OWNER:  شرکت سست و سویی آس آر ایران (سهامی خاص)	BUSHEHR PETROCHEMICAL COMPANY MEG PLANT						EPC CONTRACTOR:  Chagalesh-Enerchimi-Steam Joint Venture BUPC-MEG PLANT PROJECT		
	P&ID FOR NITROGEN GAS BOOSTER								
MC :  شرکت سست و سویی آس آر ایران (سهامی خاص)	Project	Area	Phase	Unit	Dis.	Doc.	Seq.	Contract No : 52-98/445	
Owner Document Number: 17811-03A	BU	20	VD	303	PR	DWG	0013	Rev.:	Page
								04	1 of 4

P&ID FOR GAS BOOSTER

شرکت سست و سویی آس آر ایران (سهامی خاص)	 Chagalesh-Enerchimi-Steam Joint Venture BUPC-MEG PLANT PROJECT	BUSHEHR PETROCHEMICAL COMPANY MEG PLANT
Document Review		
Issue Purpose:	AFC	
Result Code: AP,AN,CM,RE,NC	AN	
Next Status : IFC,IFA,IFI,AFC,AB	AFC	
Responsible Department	MECHANICAL	
Commented Date	Apr/11/2022	
Approval or review hereunder shall not be construed to relieve Vendor / Subcontractor of his responsibilities and liability under the contract.

DRAWING TITLE: 17811-03 P&ID FOR NITROGEN GAS BOOSTER

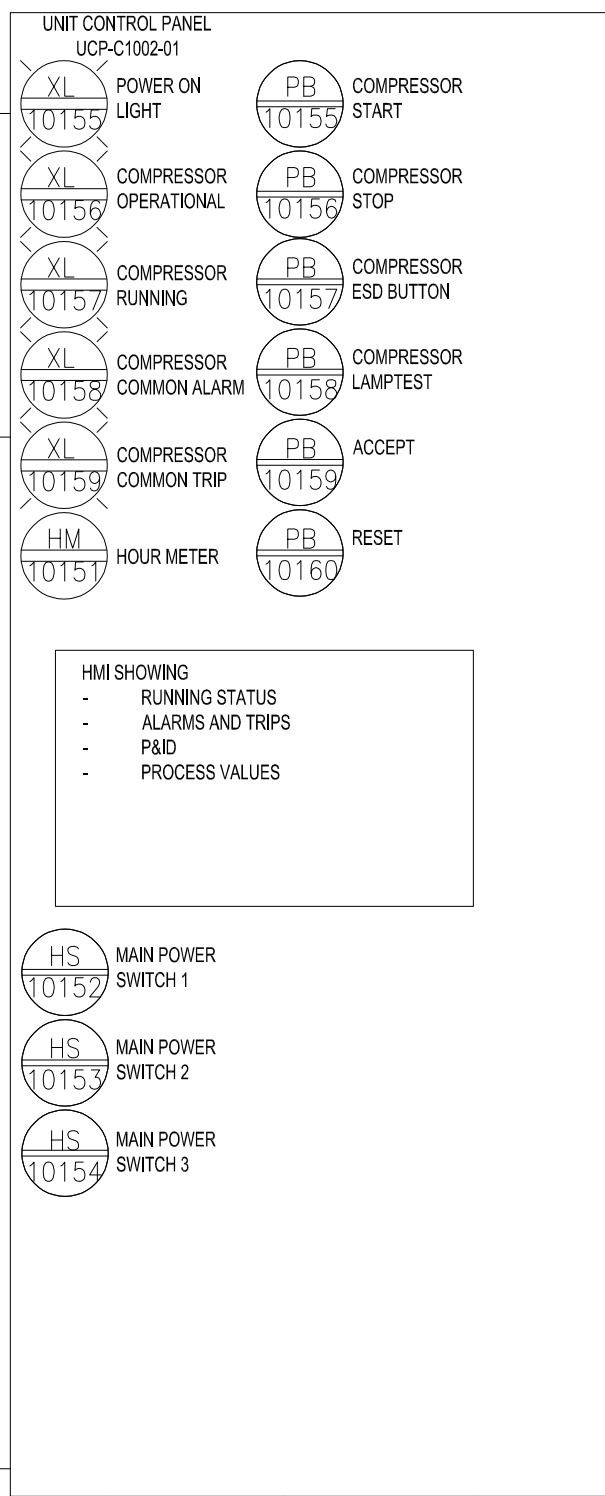
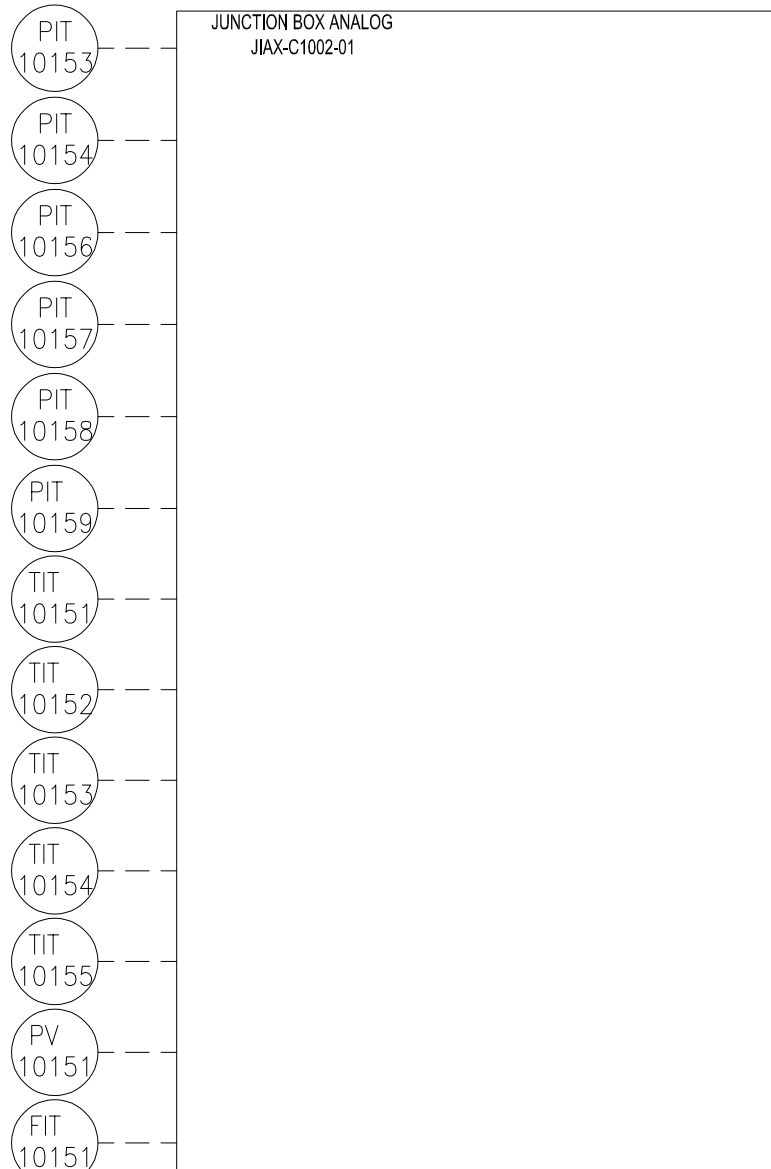
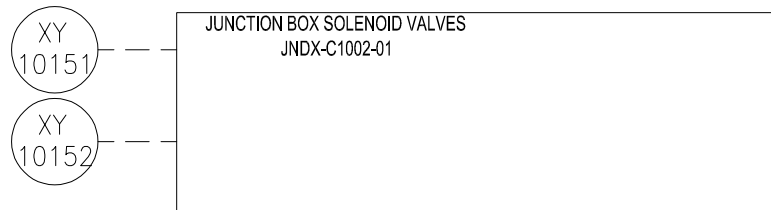
General comment:
Vendor is expected to check all document carefully and eliminate all discrepancy (for example design temperature, operating temperature and etc. is different in P&ID and pulsation dampener data sheet.

Set point for PAH-10156 has discrepancy with document Trip and Alarm Set point List that must be modified.

There is discrepancy with compressor data sheet. With reference to mechanical data sheet of instrument air compressor, discharge pressure of first stage is reported 14.5 barg.

3. Discharge of first stage is reported 14.5 bara

Shall not be less than 85 C.

TAHH (10154) set temperature is 140 C. How is it possible pulsation dampener design temperature be less than TAHH?

Please check it again considering PSV set pressure. Also as per mechanical data sheet of after cooler, design pressure is 26 bara.

1.52 oC

Design temperature shall be at least 85 C.

Shall be checked with pulsation dampener data sheet.

2. 23.5 bara
